NOTE FOR VERSION CHANGE:

CABLE P/N: 4260518-01

INVERTER CABLE PHR5/XHP-4,5, 300mm

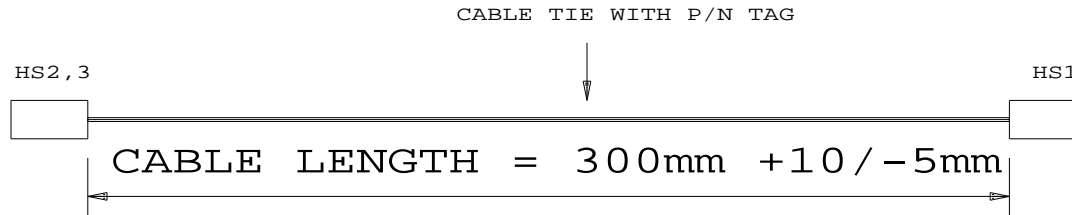
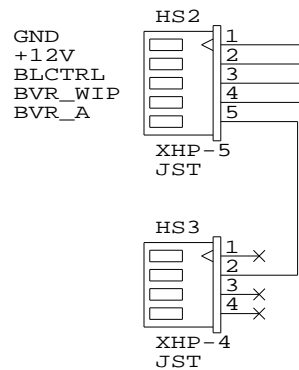
- CORRECTED CONNECTORS REFERENCE NAME
- CHANGED HS2.5 TO HS3.2 WIRE LENGTH TO 60mm
- STATED HS1 MUST USE JST
